Project:	PROPOSED POOL, SPA & ALFRESCO
Client:	CANN
Site:	35 KEEL RETREAT, PORT GEOGRAPHE

Sheet title	**FLOOR PLAN**
Date	21 Oct 2026
Revision	A
Scale	1:100

A3-01

FLOOR PLAN

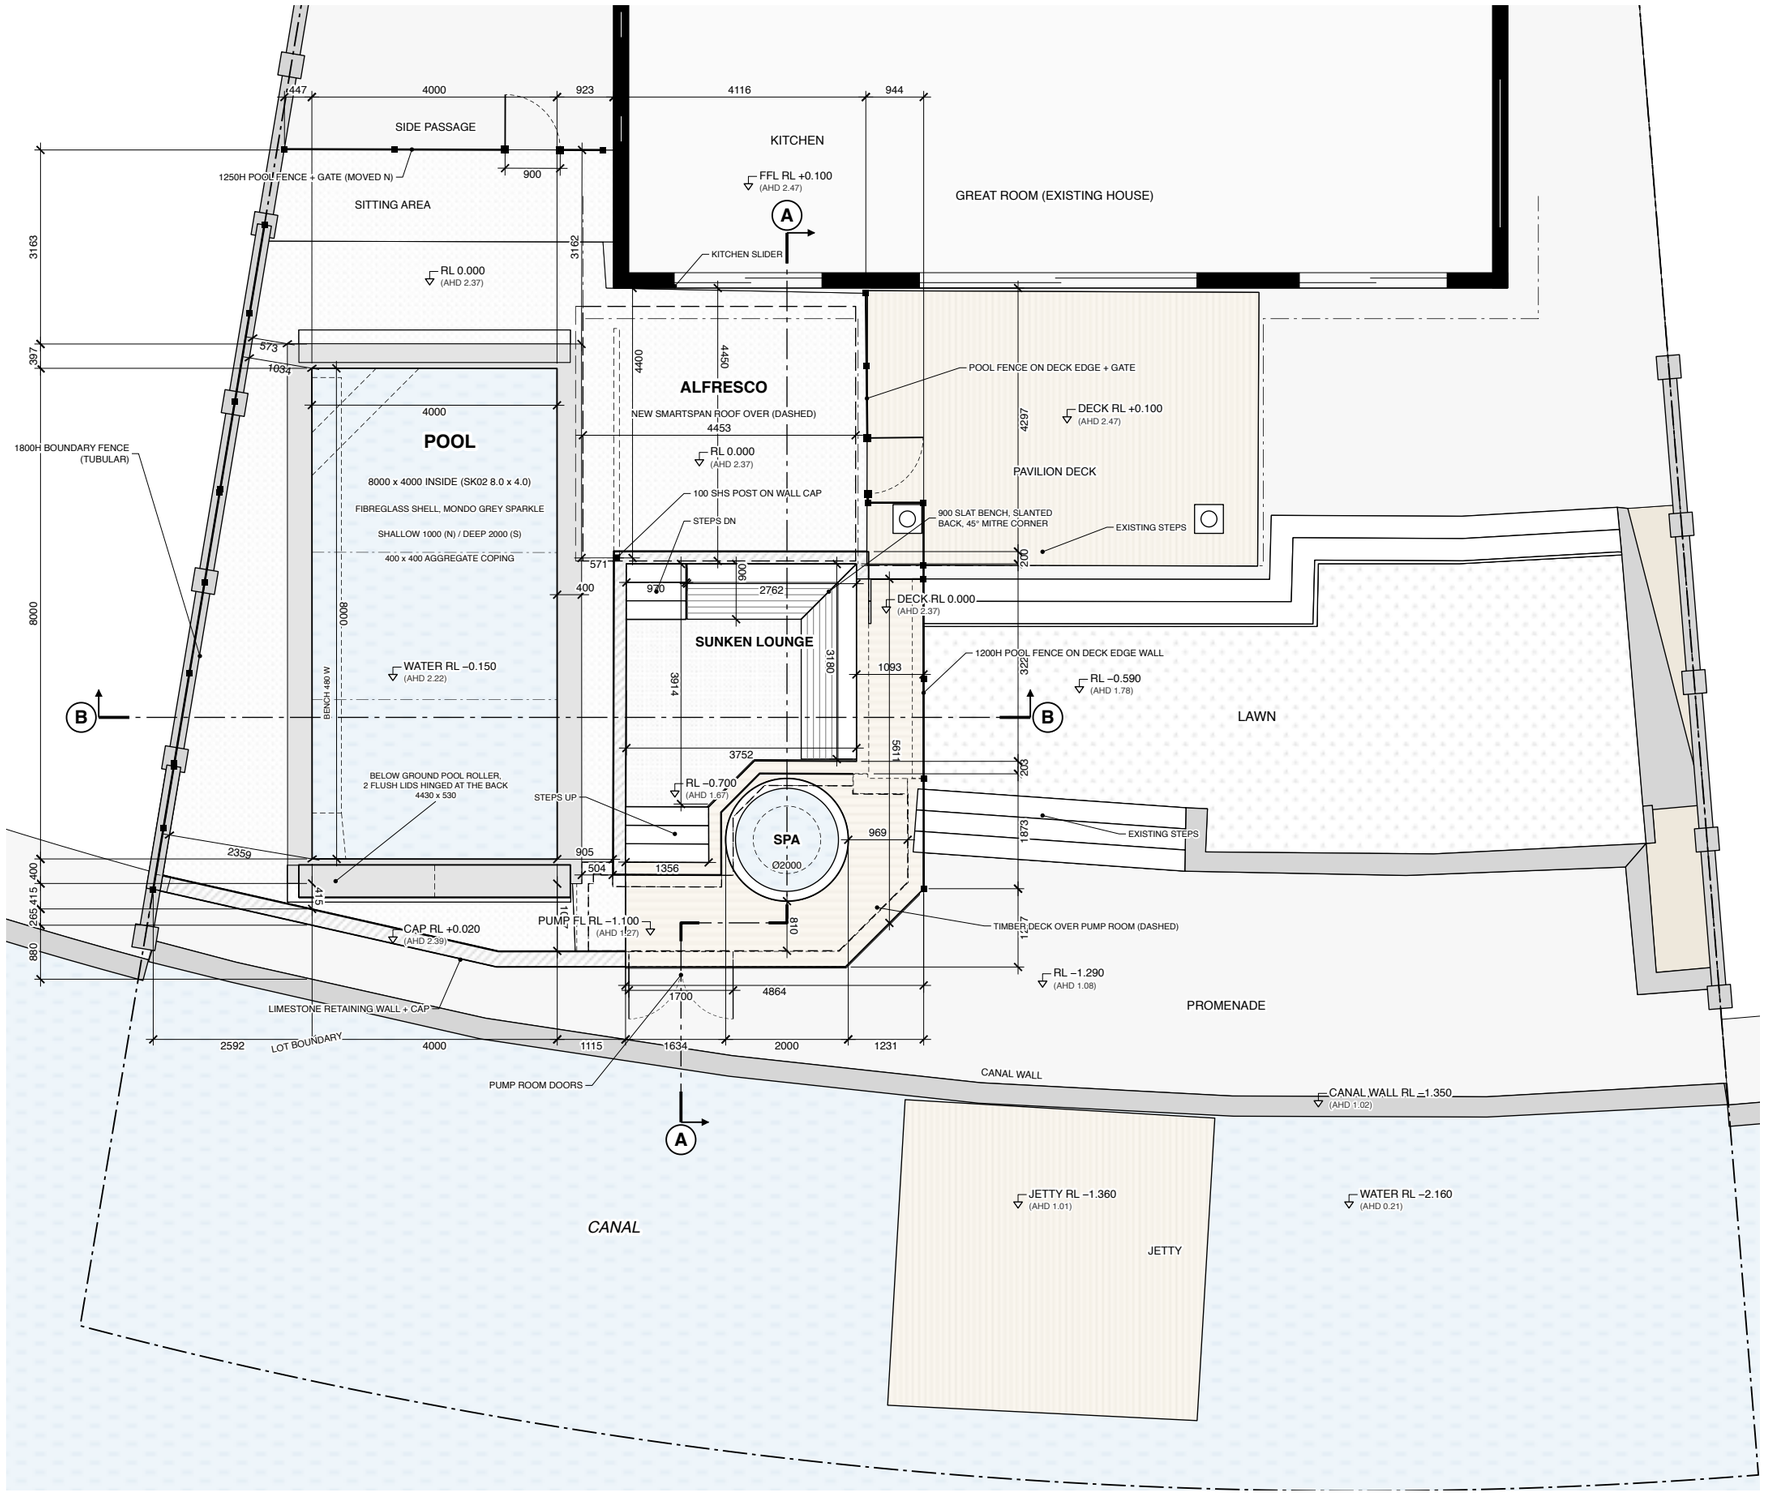
- B3 at its north end: only about 1440 above the existing lawn steps against it. OK as is?

- Pump room doors in B4, the canal-side barrier wall: their outside face must be non-climbable. Which door and finish?

- B1 and B3 stop 170 and 90 short of the house wall: close them up.
